RE: **CAO24-011** Review Letter 1; 8020 SE 57th St, Mercer Island, WA 98040

The City of Mercer Island Community Planning and Development Department has completed a review for compliance with the zoning code, Title 19 of the Mercer Island City Code (MICC) for the above Critical Area Review 2 application. The following issues need to be addressed in your resubmission:

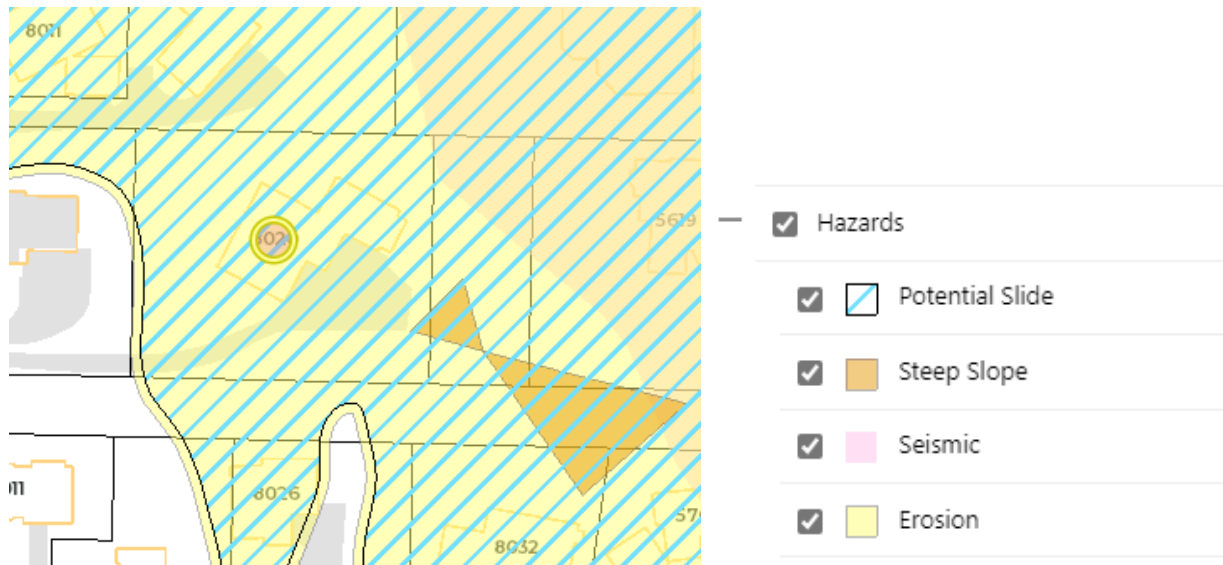
5. The submitted Geotechnical Engineering report does not discuss the required buffers for the mapped steep slope at the southeast corner of the property (see image below). [MICC 19.07.160](#)(C)(2)(a) requires a buffer equal to the height of the steep slope applied to the top and toe of slope, or, (b) if this could be considered a shallow landslide hazard area, a minimum 25-foot buffer applied in all directions. Please have the geotechnical engineer address this steep slope area, as a buffer

might be required that may encroach onto the subject property. If a buffer is required, please update the plan set to show this.
